Service Bulletin

Plastic Snap Bushings need to be added to Bulkheads and specific locations to prevent control cable from fraying or **causing cable damage.** 1. Remove interior if installed.

Section F-F

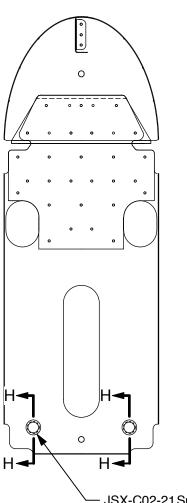
- 2. Remove Fuel Tank if installed.
- 3. Remove access panels on floor skins if installed. Up drill holes to 1/2" Diameter for Plastic Snap Bushings see Section F-F.
- 5. Install Plastic Snap Bushings.
- 6. Reinstall Control cable. 7. Reinstall access panels on floor skins.
- 8. Reinstall Fuel Tank.
- 9. Reinstall Interior.
- 10. Make Airframe logbook entry that Servuice Bulletin has been completed.
